CITY OF CHANDLER
CHANGE ORDER NO. 1
DATE 11/9/2021

Project Name: Airport Water Reclamation Facility Headworks Drain Piping
Project No.: WW2003.401
User Dept.: Public Works & Utilities NTP Date: July 13, 2021

This change order will replace two of the four 30 inch Ductile Iron Pipe running overhead between the Headworks Facility and the Pre-Stage Basin at the AWRP Reclamation Facility.

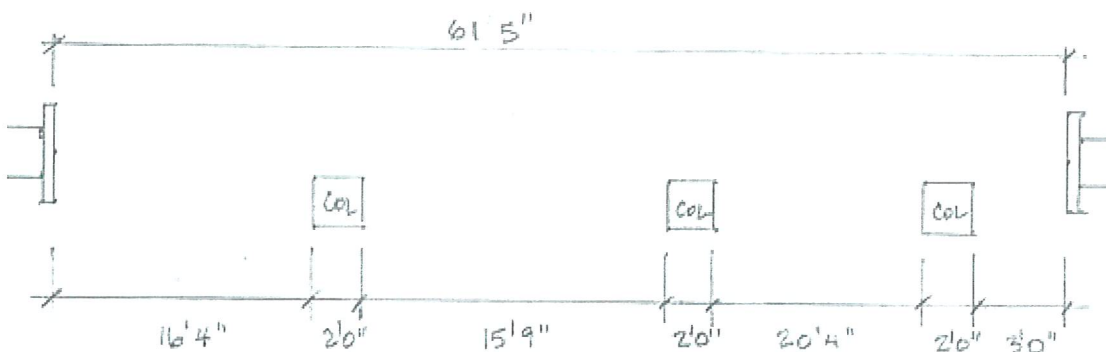
Alex,

C&B has (7) 30" Pipe and plenty of Flanges, will have to order the FBO (Flange Boss Outlets) to complete *shipping from VA/PPA

I can have the (4) Spools complete in 2 WKS ARO, but will an additional week for the FBO, will have to wait until received to complete.
